Meeting Agenda

Franklin Municipal Planning Commission

Thursday, December 8, 2022

Consideration Of Resolution 2022-65, A Resolution Approving A Development Plan For Novara PUD Subdivision, For The Property Located South Of Liberty Pike And East Of Oxford Glen Drive, At 4080 Clovercroft Road.

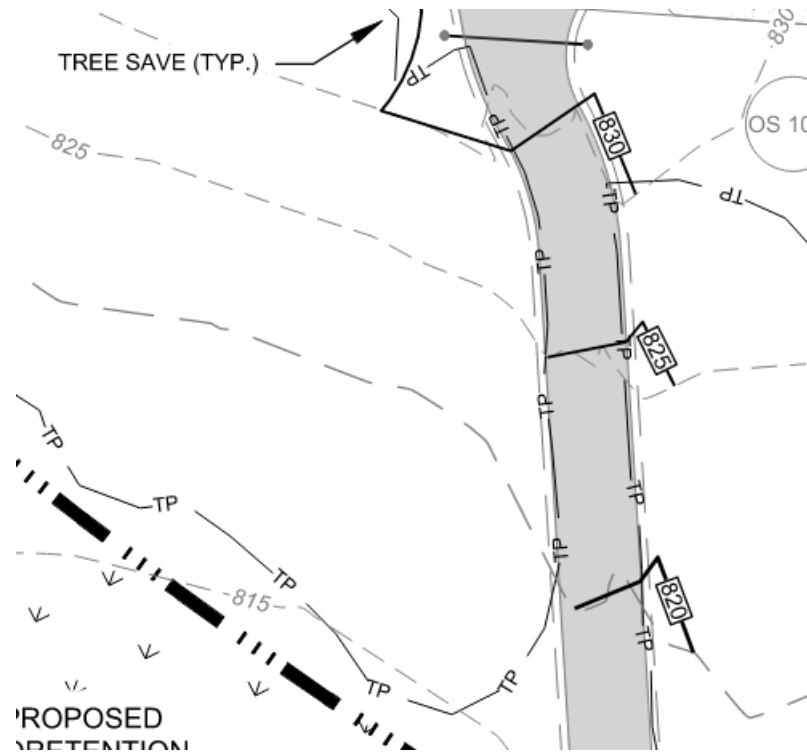
Several existing utilities are not currently reflected on the existing condition plans, including those at the intersection of Oxford Glen Drive and Clovercroft Road.

At the Site Plan stage, Applicant shall show the surveyed location of all existing utilities. Any utilities that would obstruct the typical, linear connection of the multi-use path in its final widened location along Clovercroft Road to the sidewalk on Oxford Glen Drive shall be relocated at the expense of the developer.

Sheet Title:
**ENLARGED
ROW &
ACCESS
PLAN**

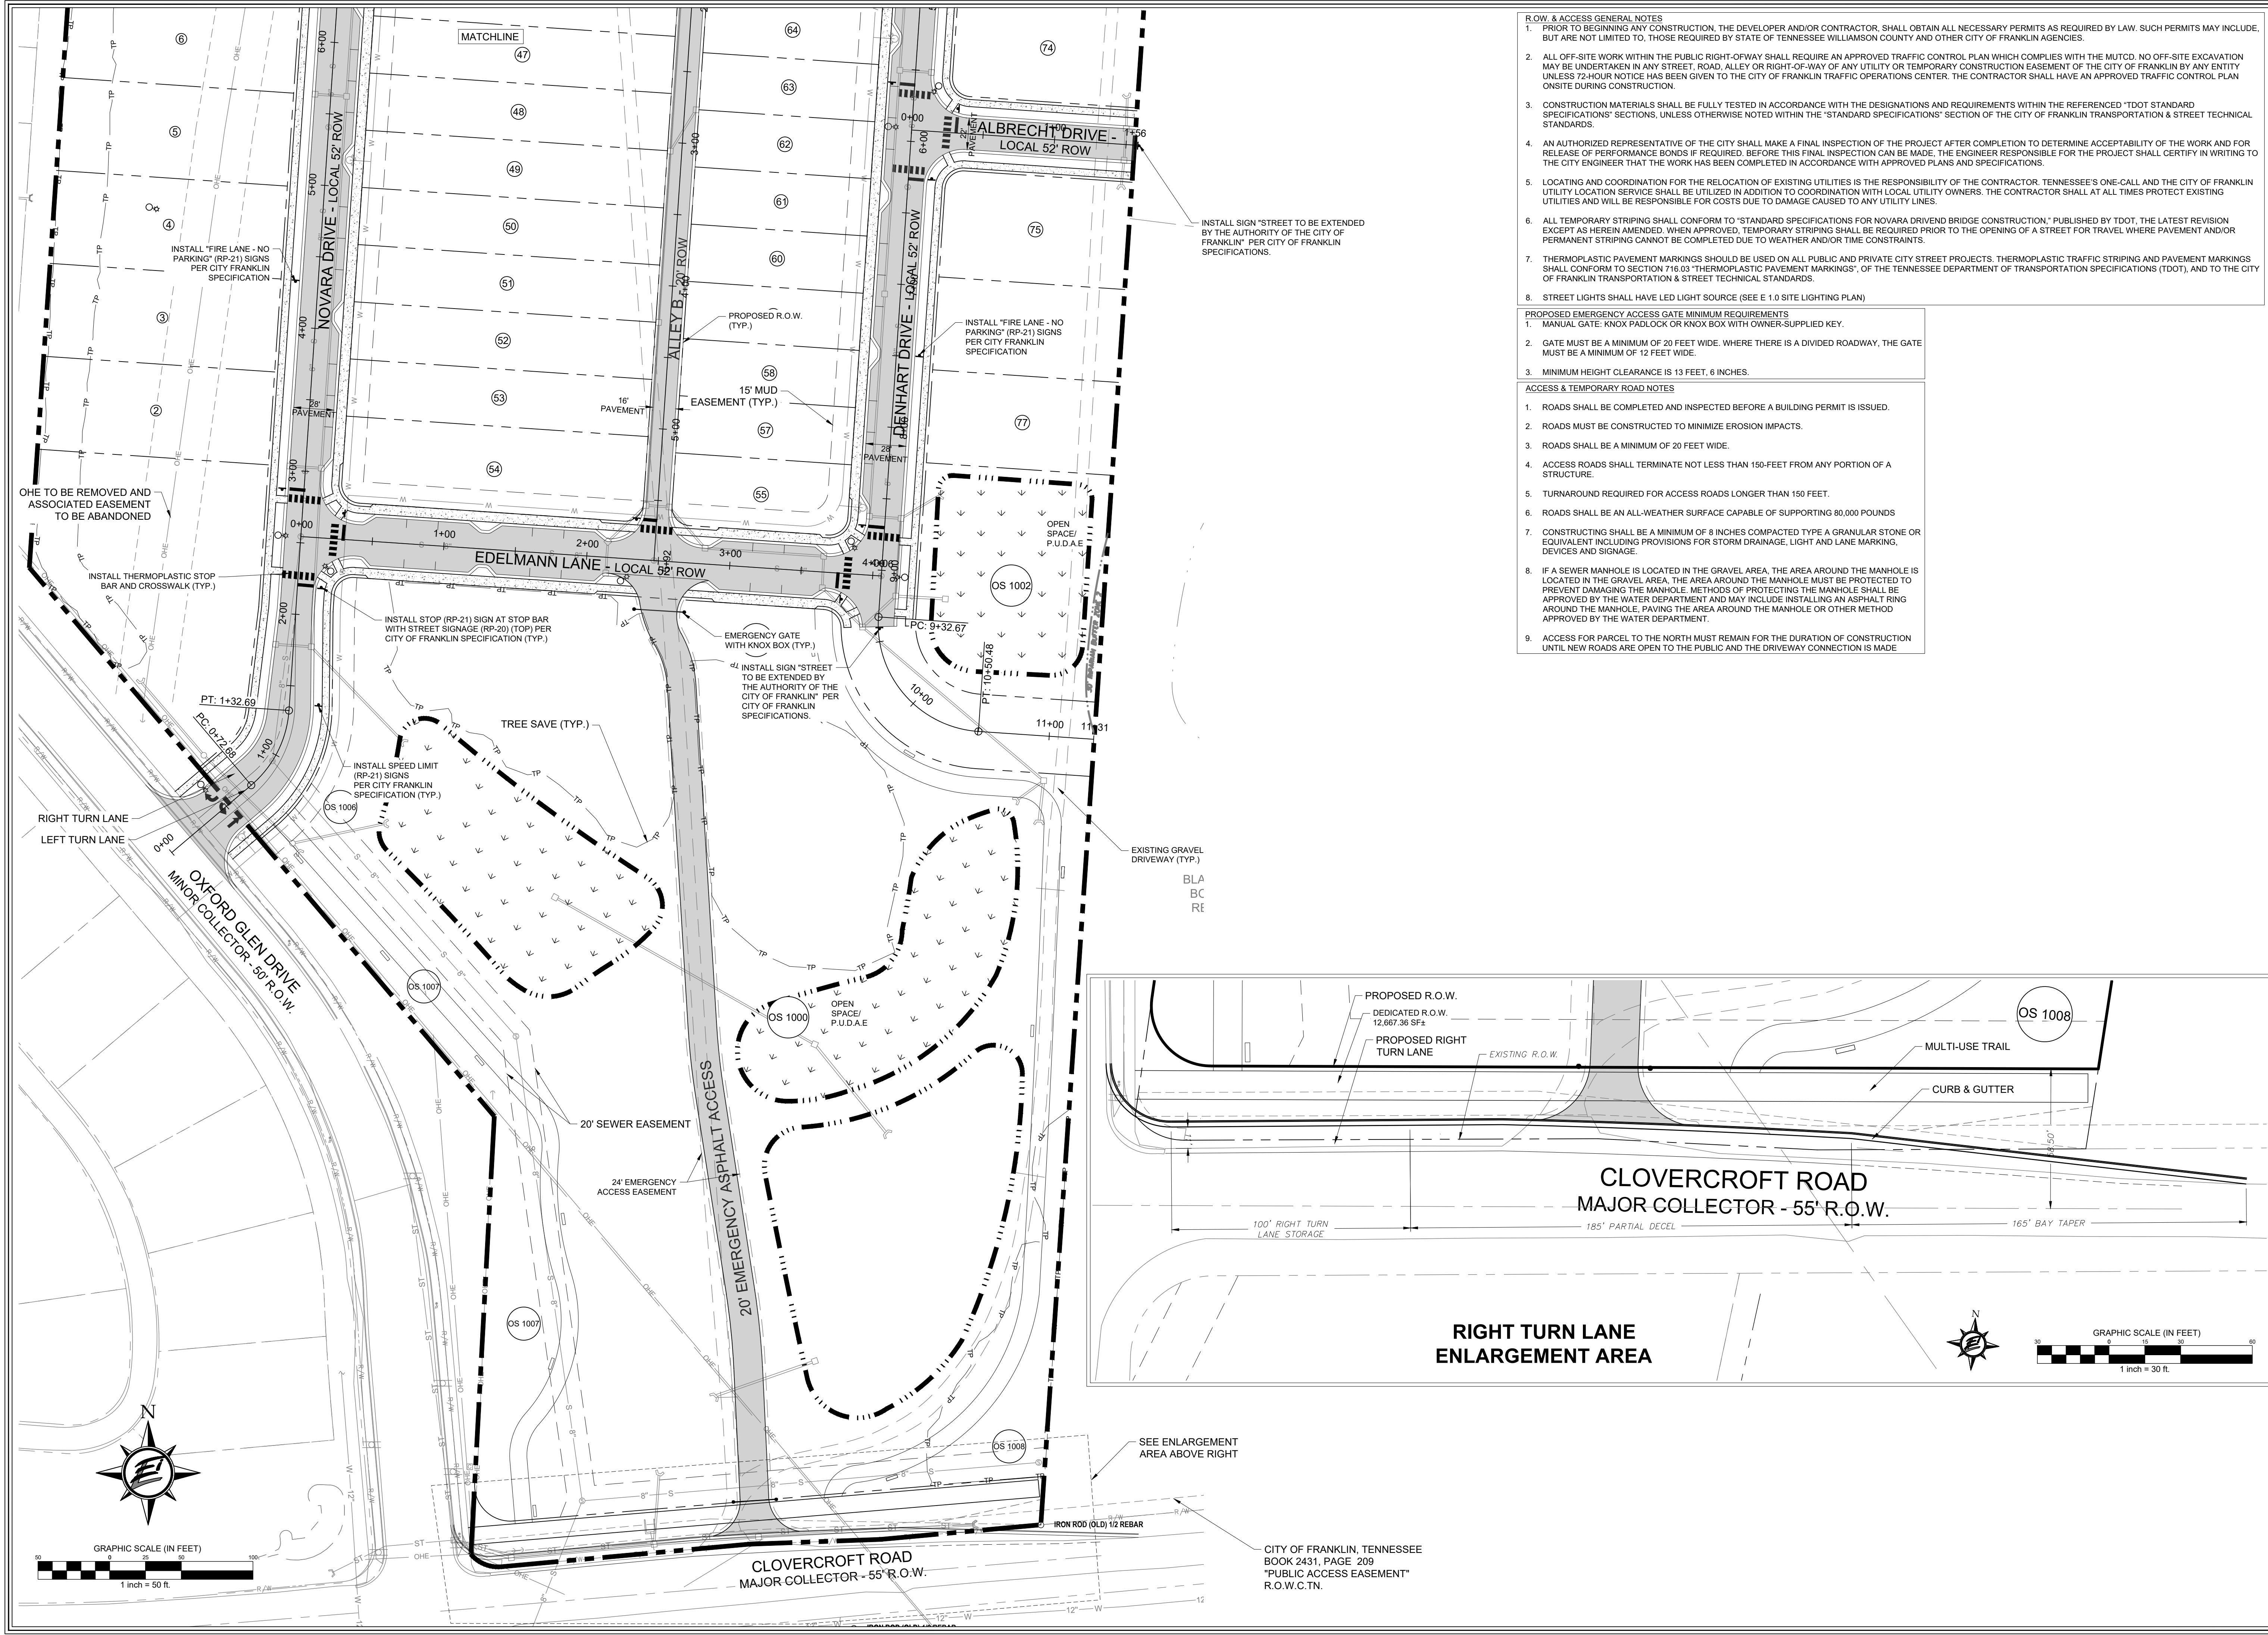
joe.marlo@franklin.tn.gov The following is a new comment due to new information shown (Sheet C4.2).

Applicant shall show and dimension all lanes in Clovercroft Road on the Enlarged ROW & Access Plan. All lanes in Clovercroft Road shall be 12-foot wide exclusive of gutter.

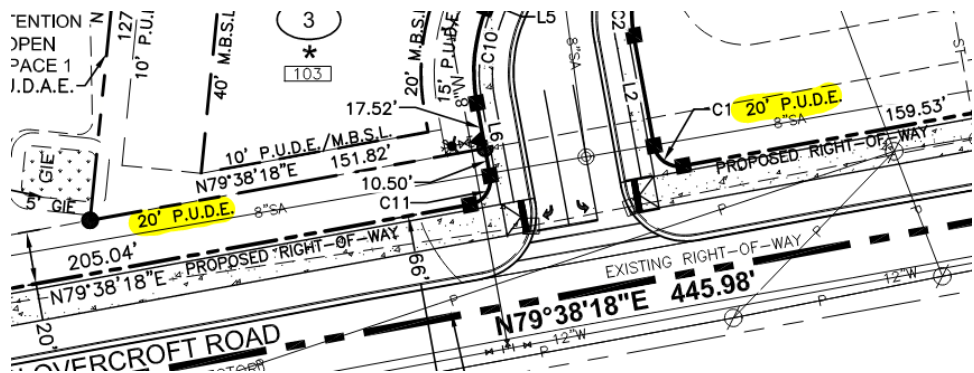
WHEREAS, the zoning has been reviewed and approved by BOMA after a public hearing and a recommendation by the Franklin Municipal Planning Commission.

SECTION I. That the following described property shall be, and is hereby, rezoned from its present zoning classification of **Estate Residential** District to **Planned (PD 2.61)** District:

23. C. Final Plat

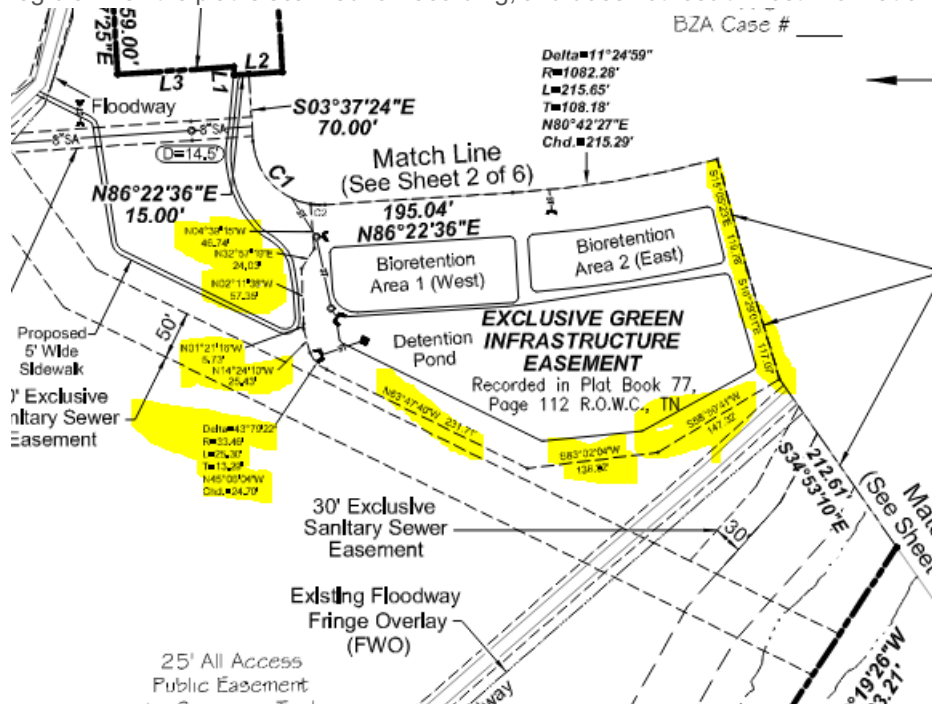
The smaller fonts used on the plat, particularly for Sheet 6, will not be legible on the recorded plat. Several examples highlighted below, but may not be inclusive of all such issues. Applicant shall provide all text on the plat of a sufficient size such that it is legible when the plat is scanned for recording, and does not result in lost information.
